Amberfield S92 Response

Landscape / Visual Effects / Open Space
Prepared for Weston Lea Ltd

17 August 2018

Figure A: Visibility of the Proposed Landform

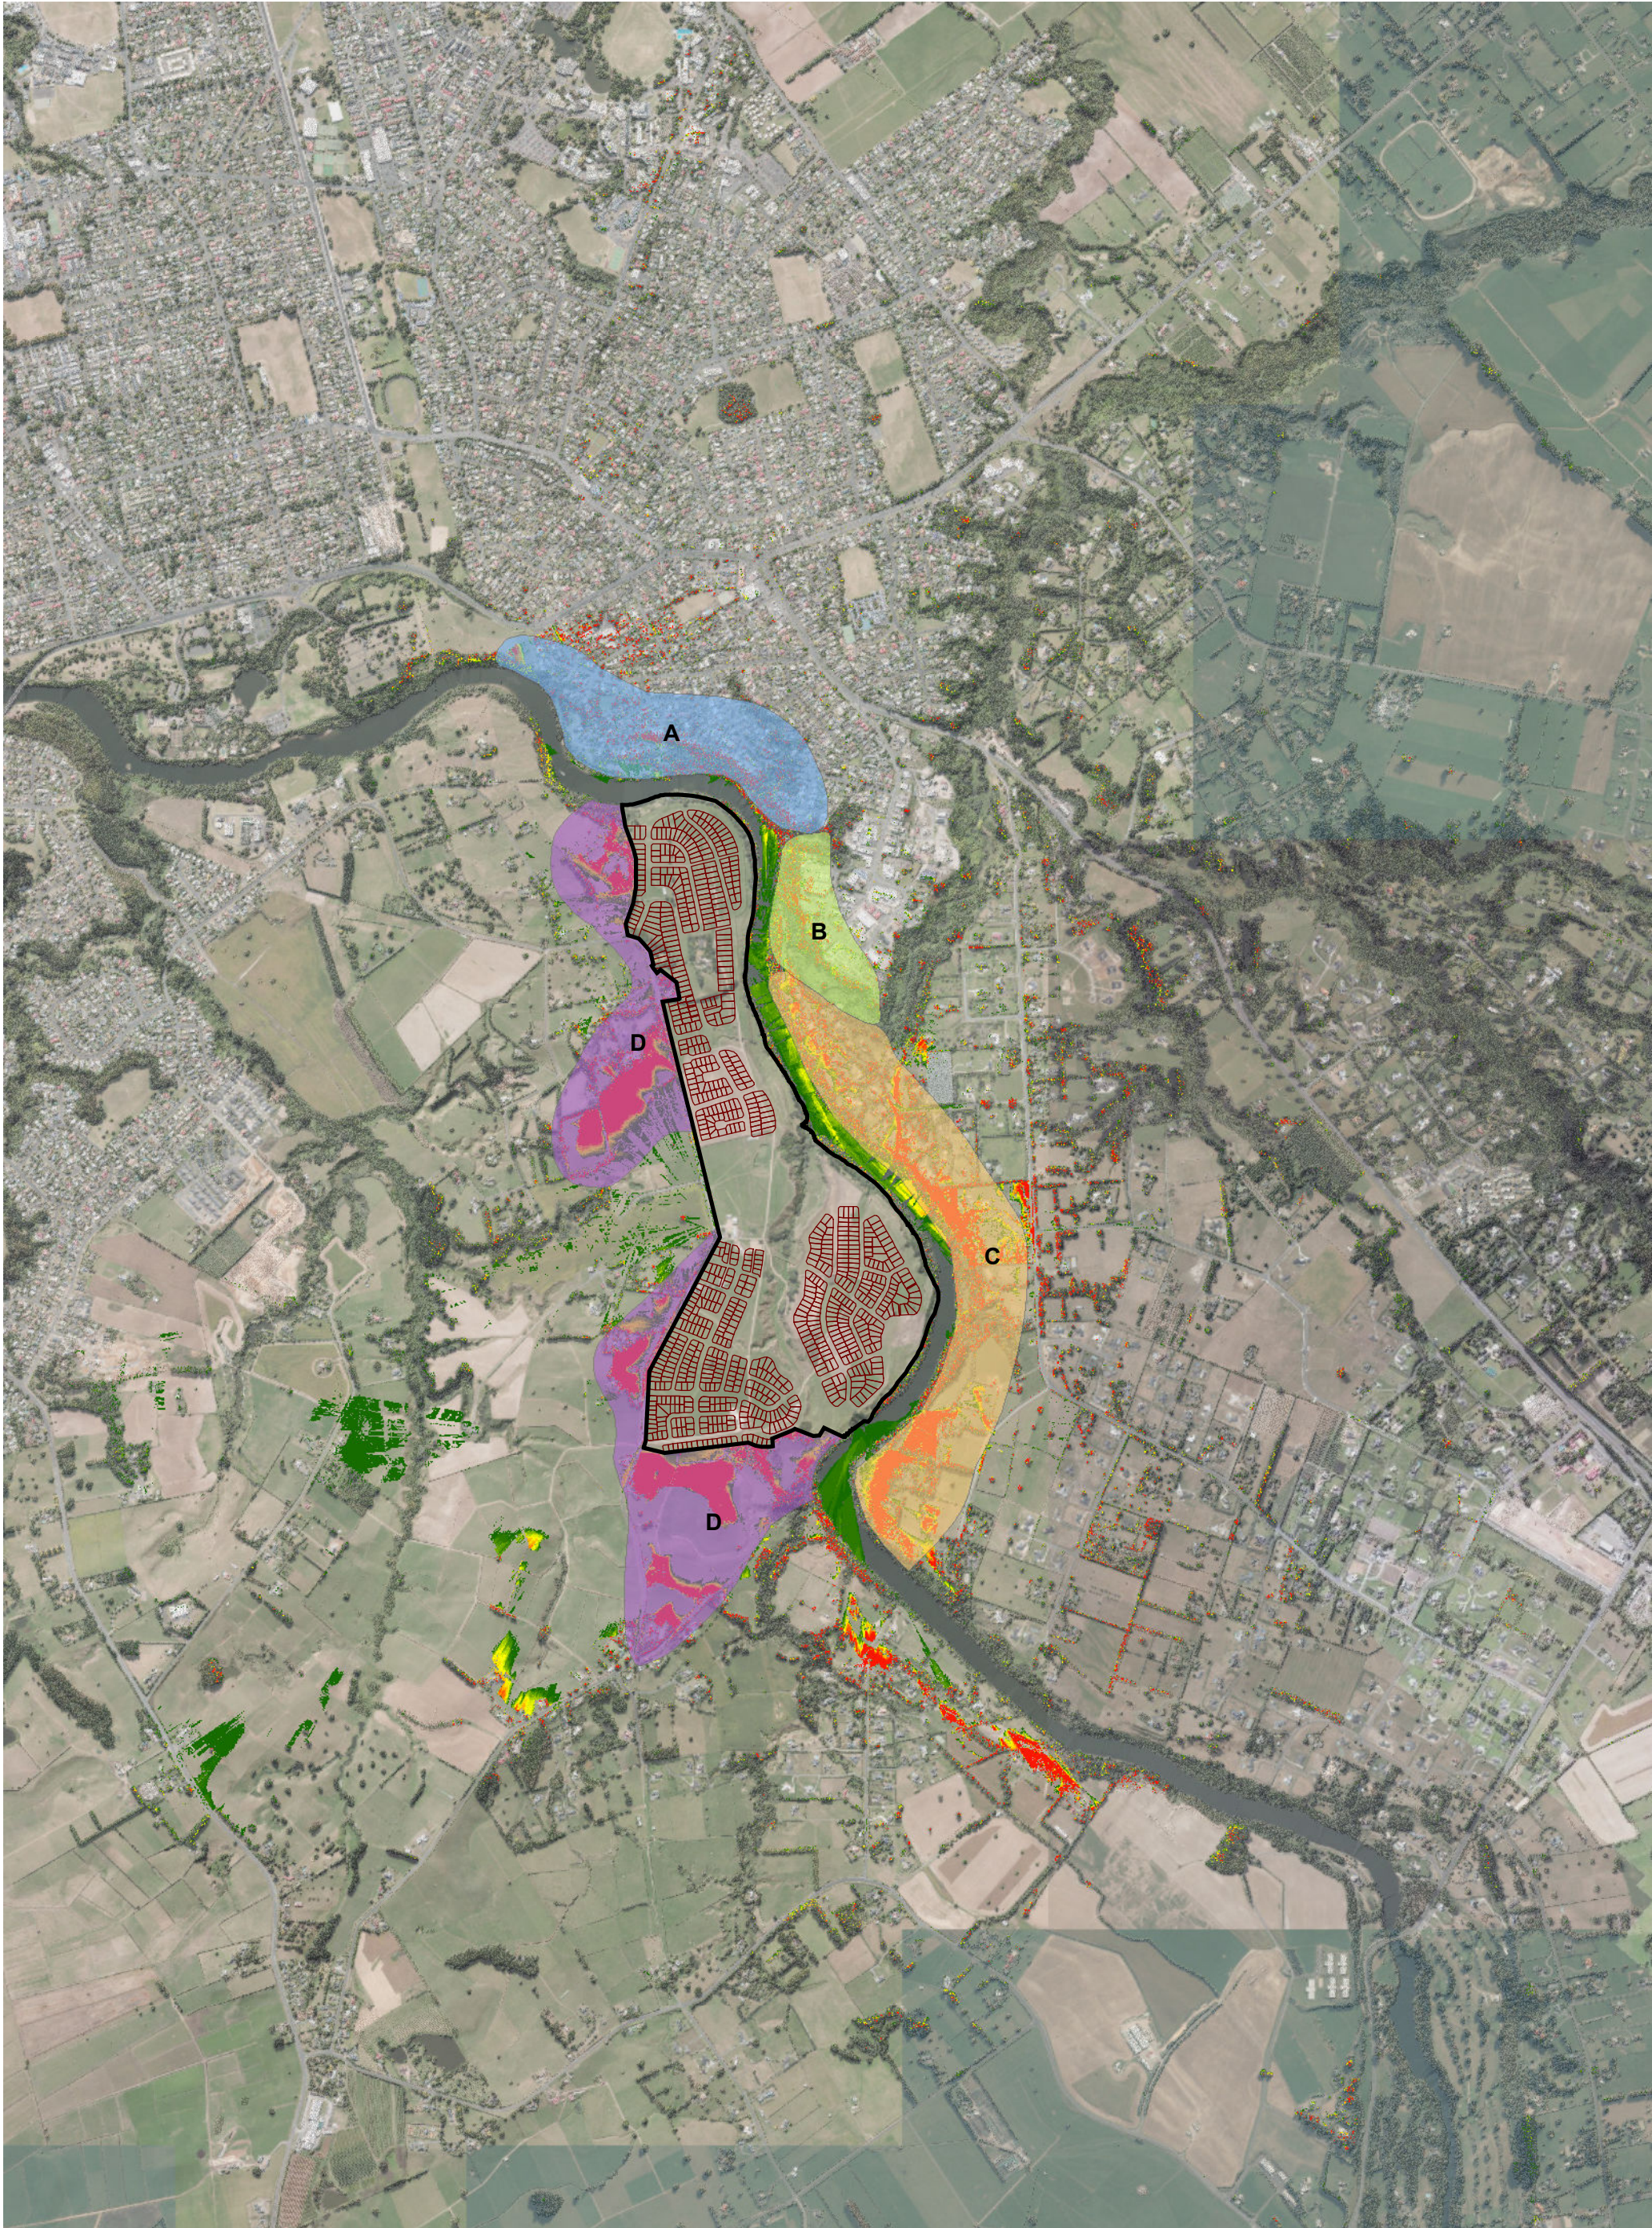
The peer reviewer has requested a more detailed description and analysis of the spatial extent of the potentially affected visual catchment and more detail in respect of the rating of effects.

Maps illustrating the ZVI in respect of the proposed landform are attached, (refer Figures A, B and C). These illustrate firstly, Figure A, the entire proposed landform and the extent of the visibility or visual catchment of the site as a whole. Figure B tests the visibility of the lower lying land in the north east of the site only and Figure C tests the extent to which the retention of the more elevated knoll landform is influencing the extent of visibility of the site.

The ZVI analysis, Figure A, has confirmed that the extent of visibility of the proposed development is limited to a relatively narrow corridor of land on the opposing banks of the Waikato River and only isolated pockets of more elevated rural land to the west of Peacocke Road and in the south of the site.

Section C-C'

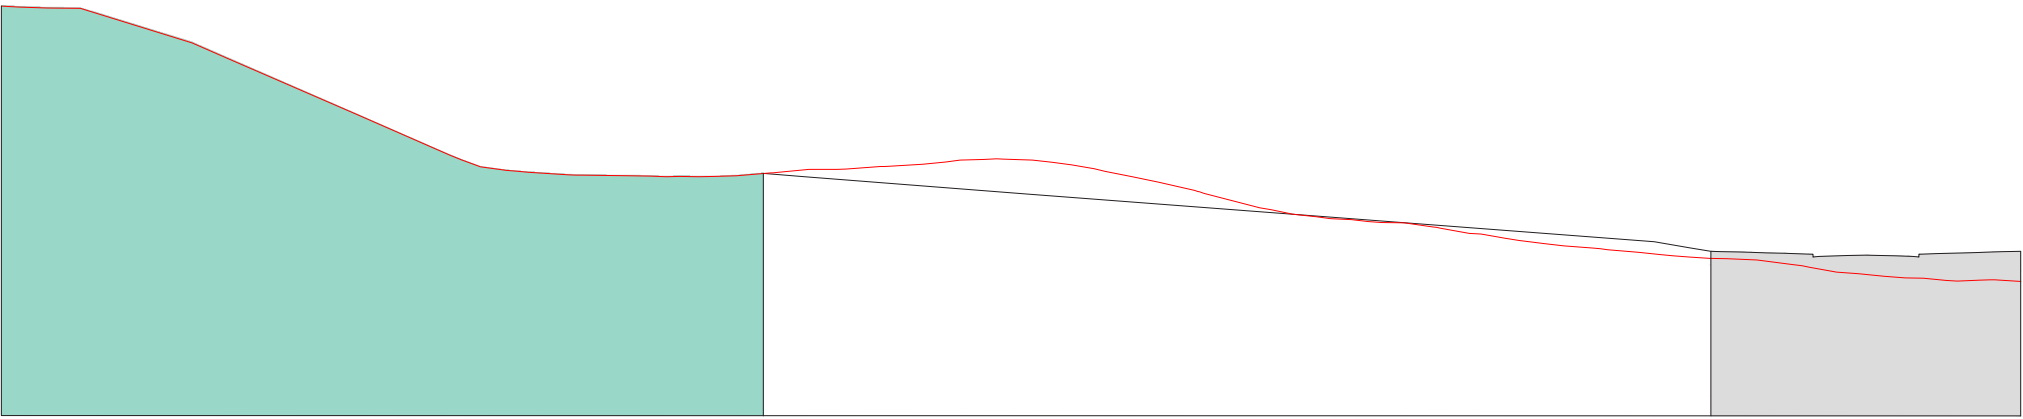
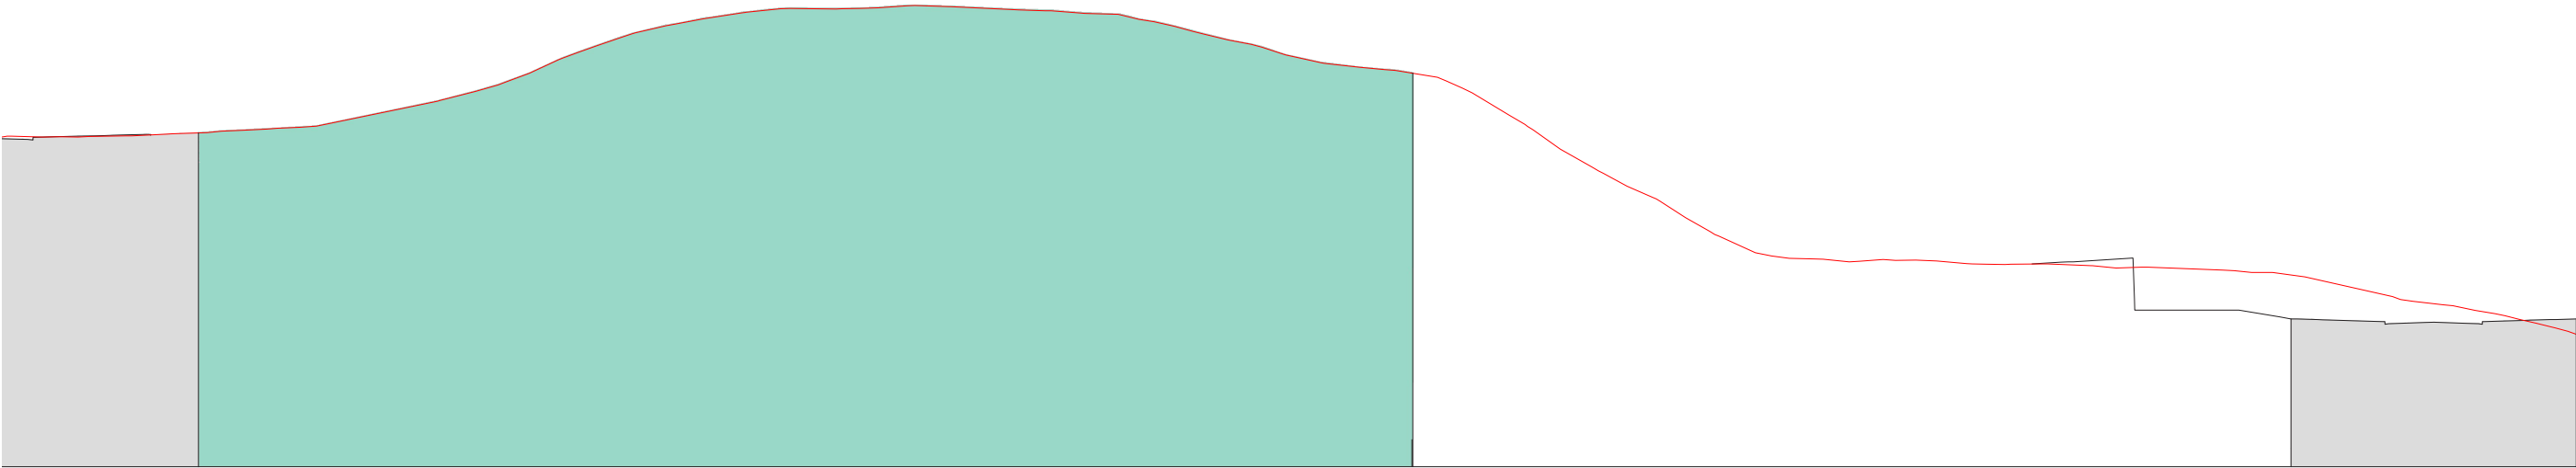
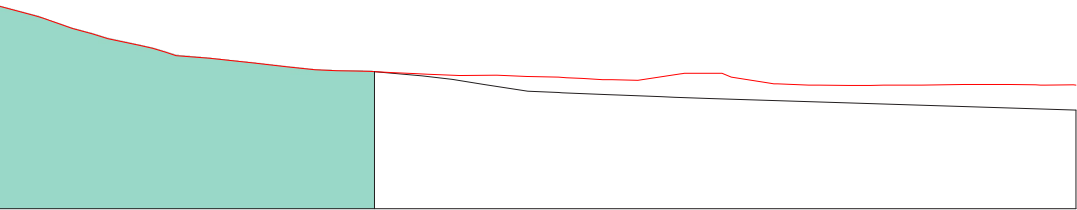
Section 4-4¹ shows the retained knoll landform with a cut on the eastern side to establish the road and a flat access onto the residential lot which adjoins the knoll reserve. This layout, as further illustrated in Section C-C¹ Figure 1, locates a retaining wall set into the lot which would relate to a step in the building platform.

Figure K: Ground Level and Top of Roof Recommended Height Restrictions

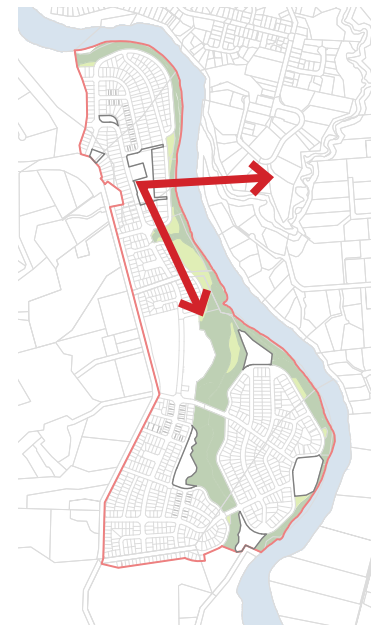
An assessment of potential building platform heights directly to the east and south of the Knoll Reserve has been undertaken to determine the potential impact of future dwellings on these Lots on public views from the Knoll - including desired views to the river corridor and wider site.

The ground level of the Knoll within the reserve at its highest point is surveyed at an RL of 44.5m. An infringement on this height plane, resulting from any future dwellings within the cone of view, would impact the desired public view from the knoll within the reserve.

Lots 144-150 and Lot 155 have been assessed. A diagram of the proposed extent of the cone of view is provided in Figure K appended to this report. Lots 151 – 154 and Lots 156-158 which lie directly south of the Knoll will not impact on the protected cone of view and hence no height restrictions are proposed on those Lots.

The anticipated building platform heights (GL RL) of the subject Lots is noted on the attached plan (Figure K) with a 'top of roof' RL also prescribed for each Lot. It is considered that these 'top of roof' RLs are best utilised to control maximum dwelling height while maintaining flexibility with regards to the form of the future roof and the number of storeys a dwelling can be constructed to within the specified RL height. For Lots 144 through 150 and Lot 155 (8 lots in total) a small reduction to the potential 12 or 12.5m maximum permitted heights are proposed through the 'top of roof' RL limitations. The most restricted Lot is Lot 155 where a 6m building height is provided enabling two storey, flat roof development. On all other lots generous two and three storey heights are maintained.

AMBERFIELD
PEACOCKE STRUCTURE PLAN
Figure M: Fence
Height Restrictions on
Residential Lots Adjacent
to Open Spaces

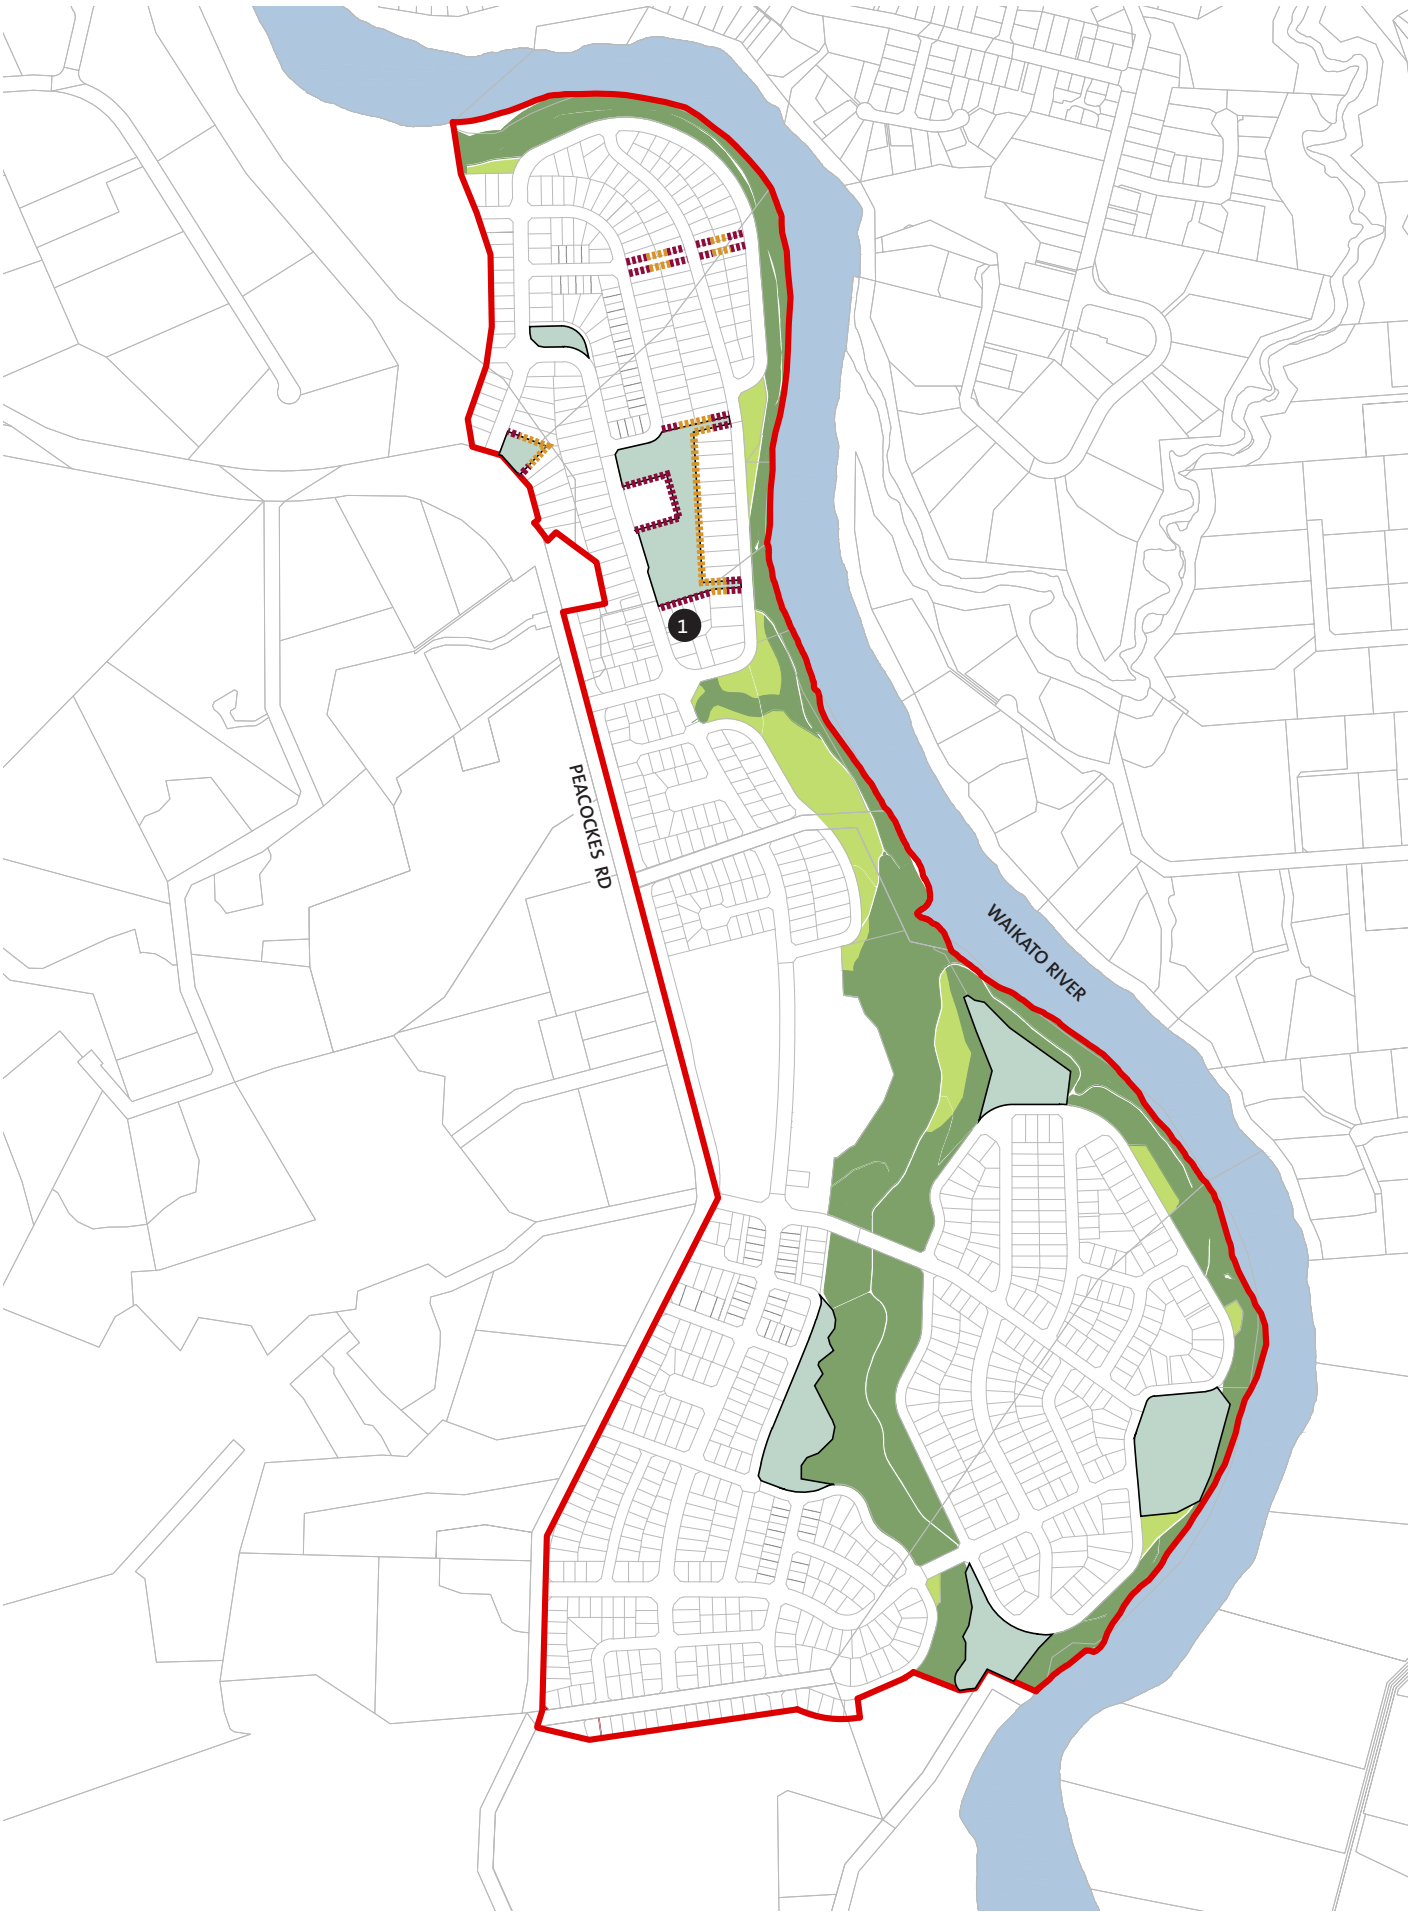
Please refer to Figure M for map identifying these boundaries.

It is considered that a 1.2m fence height restriction would be appropriate to apply to Lot 25 (the proposed café / sales office Lot) which sits surrounded on 3 sides by the Knoll Park, the front fences of Lots 155 – 158 which are rear lane accessed lots fronting Knoll Park and the side boundaries of all residential Lots where a fence is adjacent to the front yard and side of dwelling. In all other instances the Hamilton City Council District Plan Rule 15.4.6 would apply to the boundaries i.e. where rear yards are adjacent to reserves and walkways. A copy of this rule is referenced below.
